## Combined Member's Briefing Pack for:

2021/0162/P – 9 Tobin Close

Delegated Report (Members Briefing)		Analysis sheet	Expiry Date:	1. 08/03/2021 2. 11/03/2021 3. 22/03/2021 4. 08/03/2021
		N/A	Consultation Expiry Date:	1. 14/06/2021 2. 14/06/2021 3. 12/06/2021 4. 14/06/2021
Officer			Application Number(s)

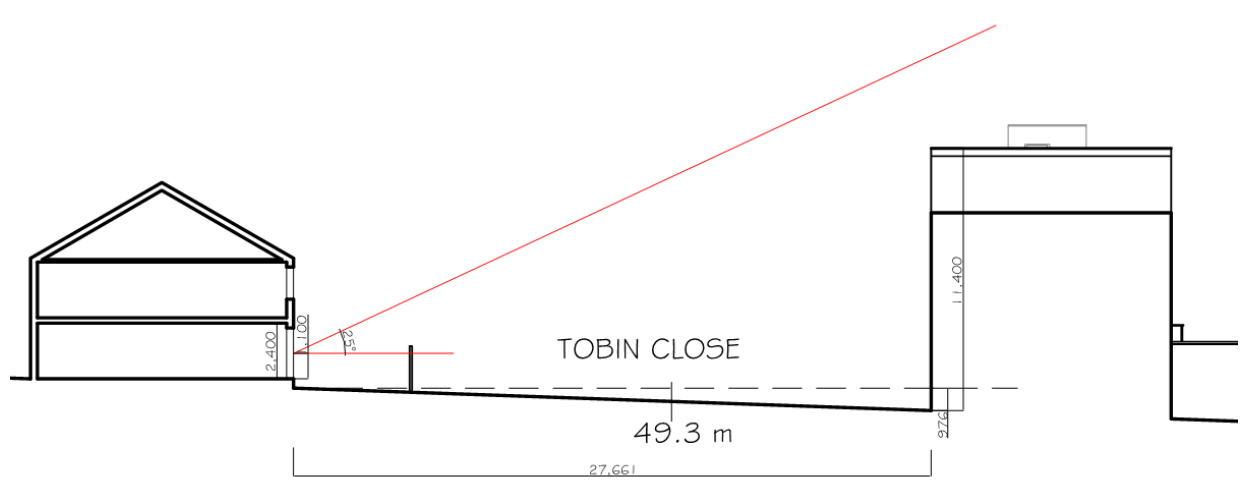
2.6. The applicant's daylight and sunlight submission demonstrates that the proposed development would be below the 25 degree line (as shown below). The BRE guidance states that if this angle is less than 25 degrees for the whole of the development then it is unlikely to have a substantial effect on the diffuse skylight enjoyed by the existing building.
